**ANVIL RANGE PROPERTY
2007 DAM SAFETY REVIEW
Cross Valley Dam, Intermediate Dam,
and Little Creek Dam**

April 9, 2008

**Anvil Range Mining Complex
2007 Dam Safety Review for
Cross Valley, Intermediate and Little Creek Dams**

CLIENT DELOITTE & TOUCHE INC. ANVIL RANGE MINING COMPLEX	
PROJECT 2007 DAM SAFETY REVIEW	
TITLE CROSS VALLEY DAM TYPICAL DESIGN SECTION	
PROJECT No. M09237A05	PDL No. 3

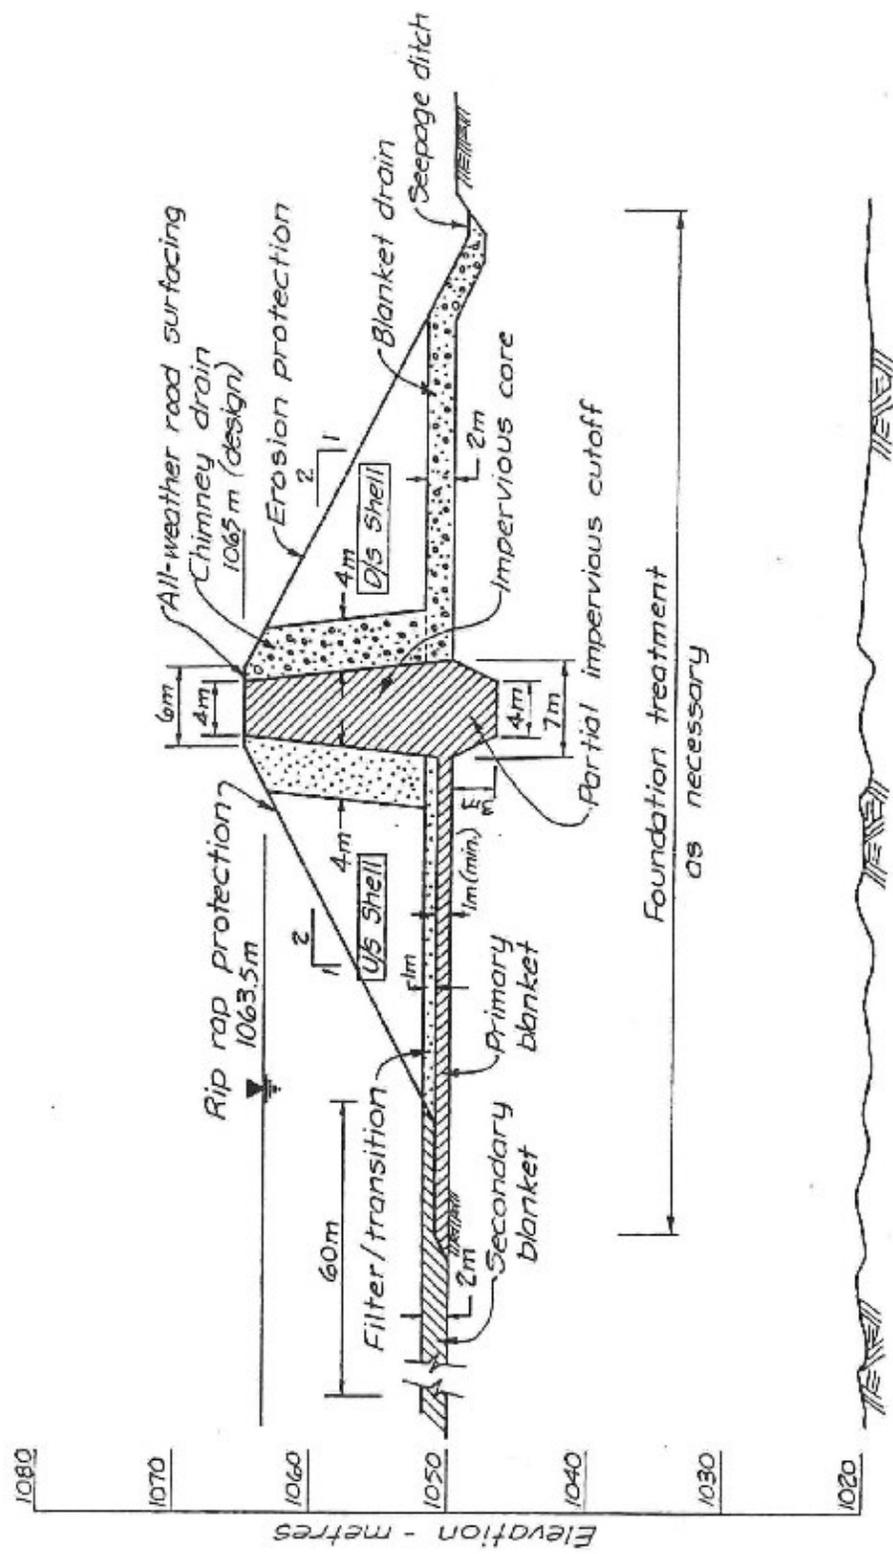
Although mentioned in the BGC Operating Manual, record drawings do not show the seepage blanket at the toe of the Cross Valley Dam. The seepage blanket was built in the early 1990s after more than 10 years of operation of the Cross Valley Dam which was built in the early 1980s. This seepage blanket needs to be shown on the record drawings for the Cross Valley Dam.

Also shown on Photos II-8 and II-9 is the “seepage” berm on the downstream toe. This berm is separated from the toe road by a ditch. Although not shown on any of the drawings available to the writer, this berm was apparently constructed to control seepage at the toe of the dam. Near the right abutment, geotextile beneath the toe berm is exposed in the toe ditch as shown on Photo II-12. There is no sign of seepage discharge from the top of the toe berm so the toe berm elevation is above any artesian pressure heads at the toe. The berm toe is lined with rockfill as shown in Photos II-11 and II-12.
